ADDENDUM NUMBER ONE

DARLA MOORE SCHOOL OF BUSINESS CONSTRUCTION – BP-3
ENCLOSURE/SITE/MEFP/INTERIOR
UNIVERSITY OF SOUTH CAROLINA
STATE PROJECT NUMBER H27-6069-AC-3

DATE OF ISSUE: June 04, 2012

ENLARGED PLANS - TRANSFORMER VAULT
 REF. DWG # 01 & 02/A0331
 SHEET TITLE :

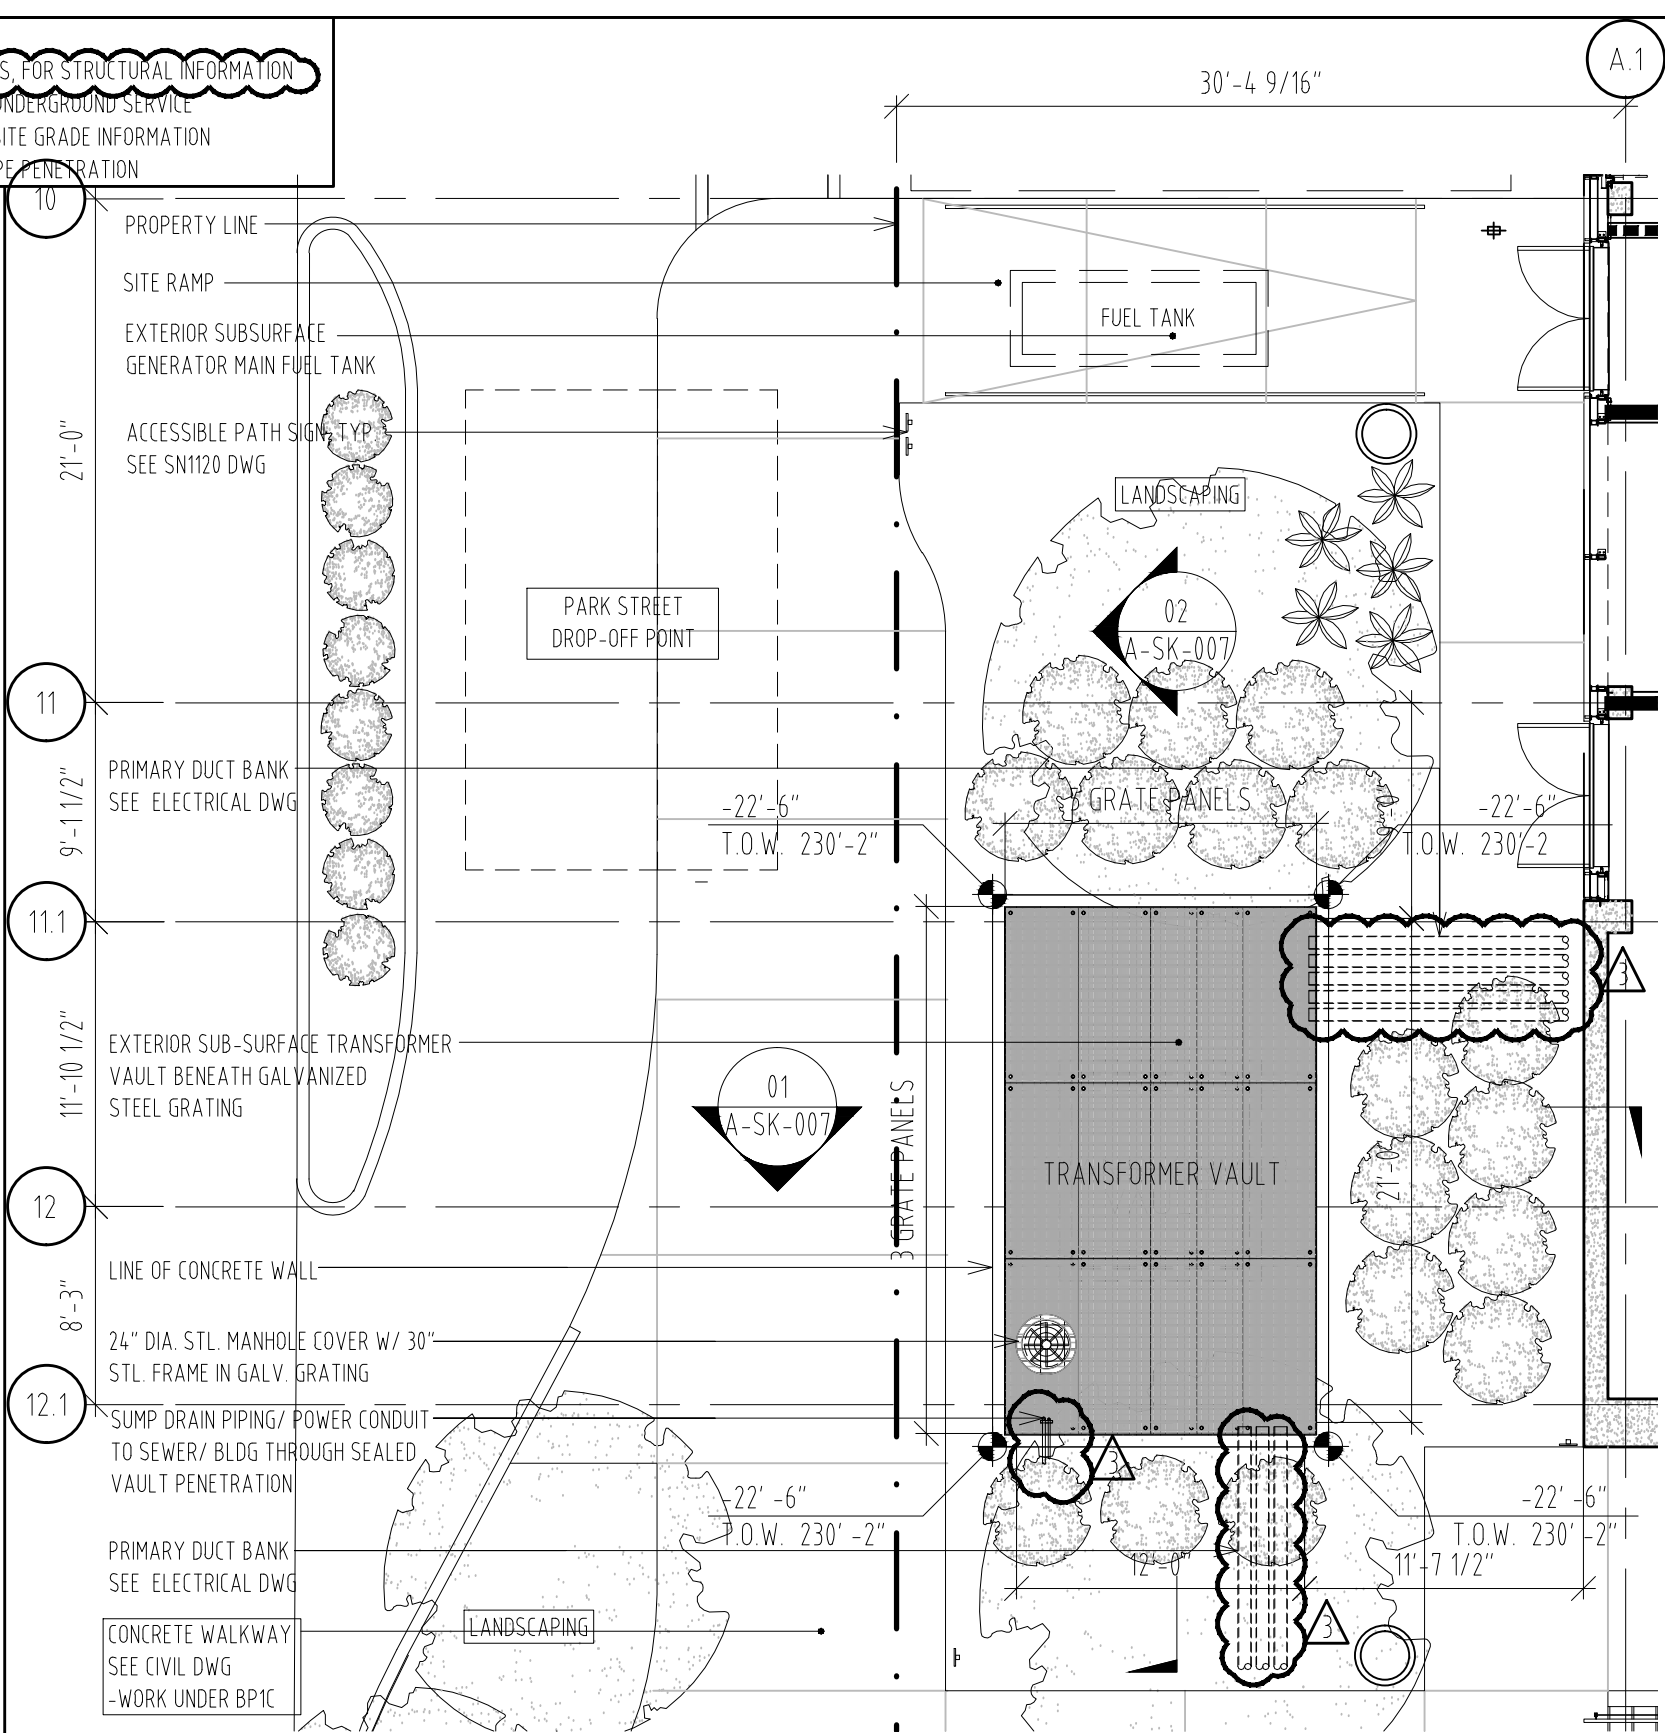
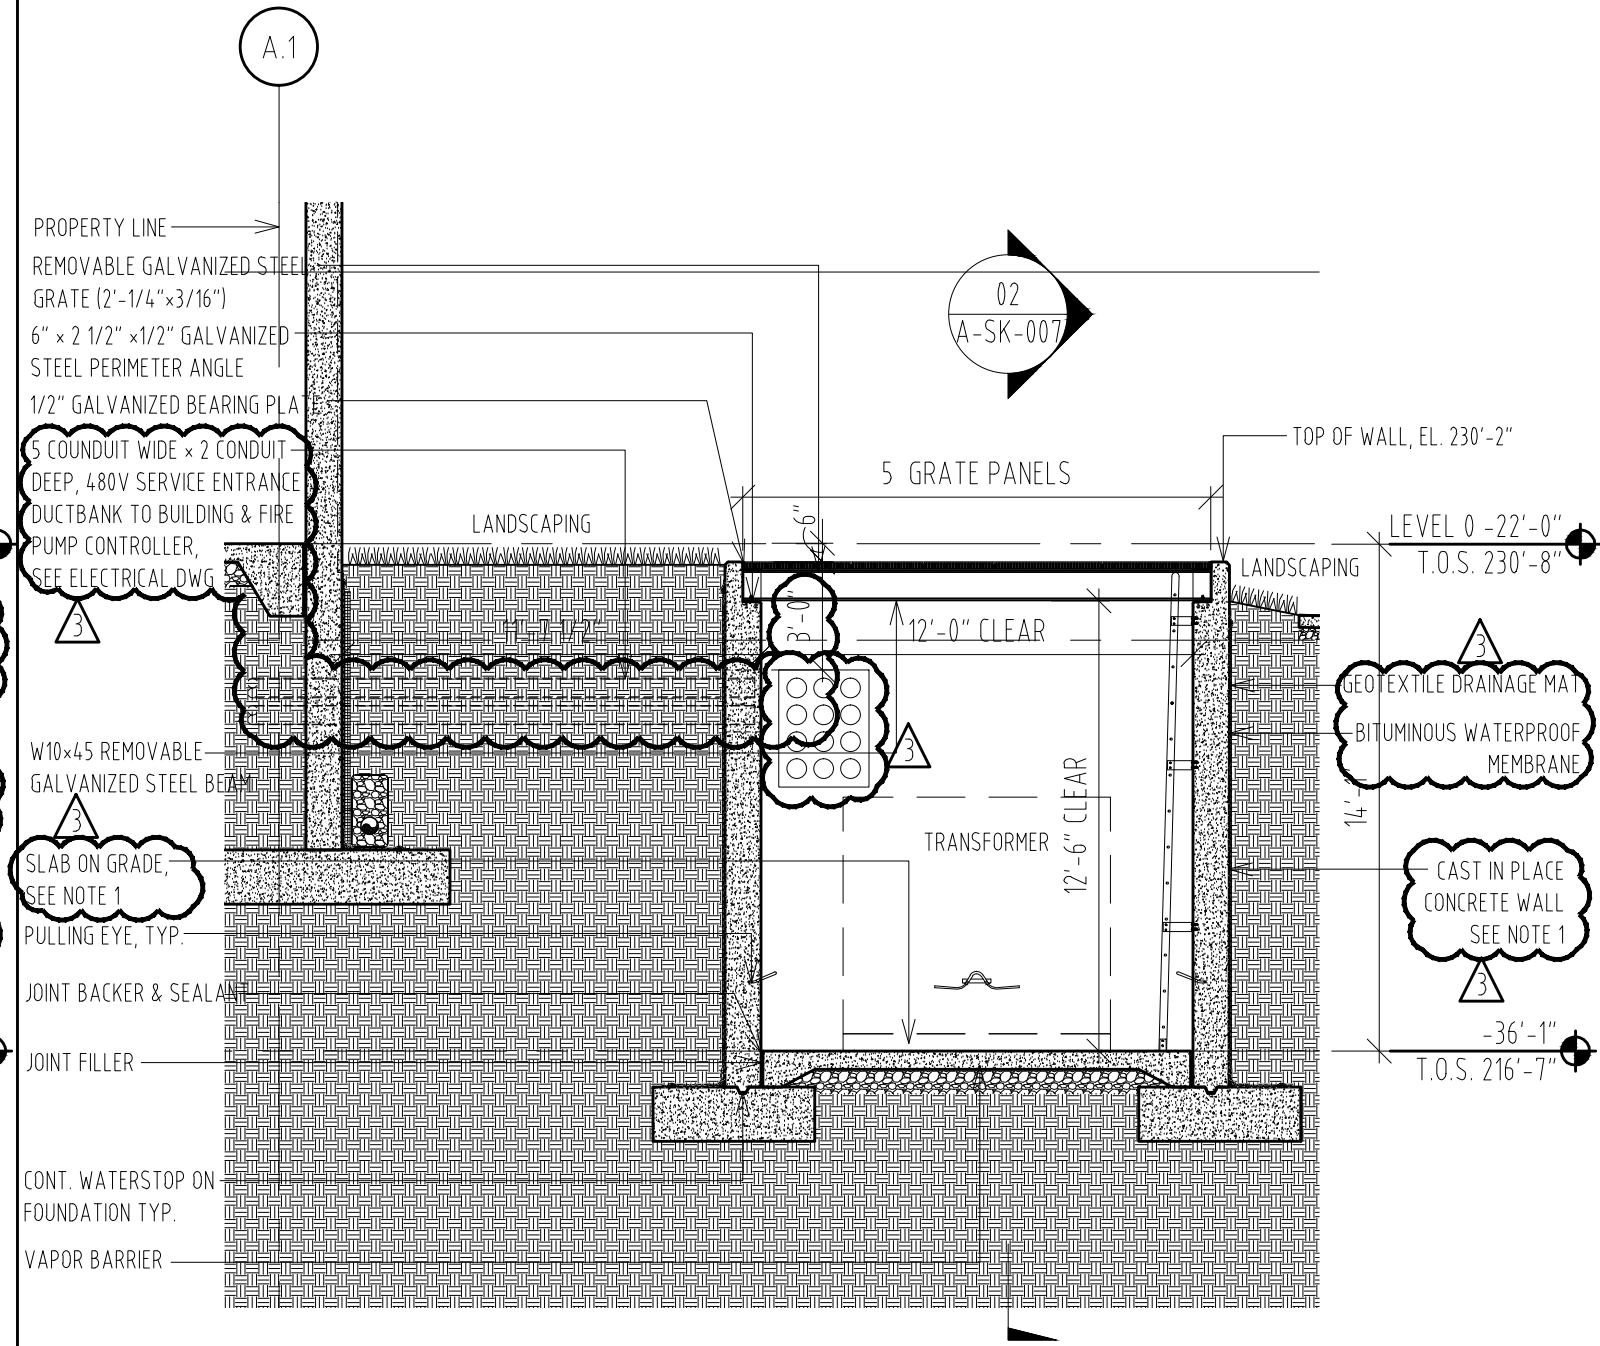
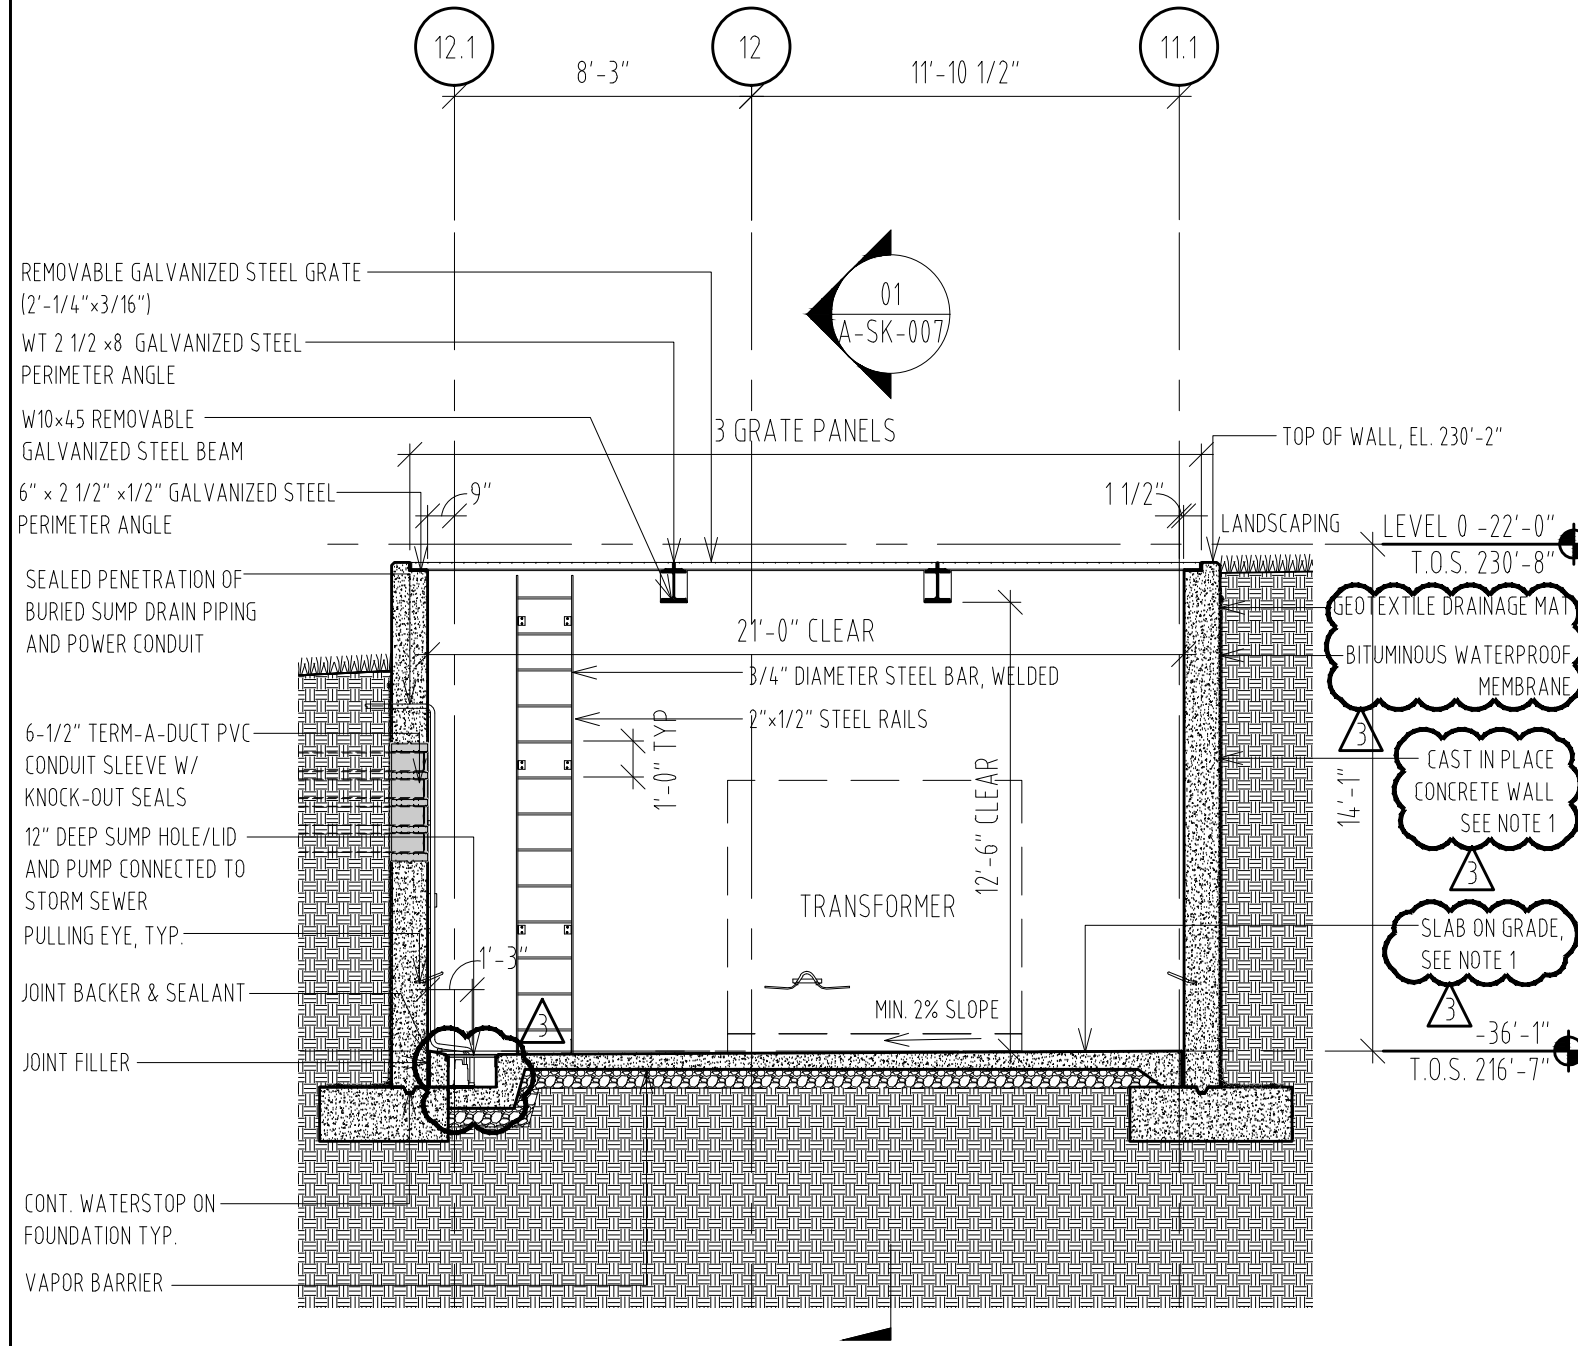
5.	Plan Sheet A5112 & A5121: Refer to attached sketch A-SK-005. Accessible site parking dimension clarifications.
6.	Detail Sheet A0331: Refer to attached sketch A-SK-006 and A-SK-007. Revisions to subgrade electrical transformer vault construction.
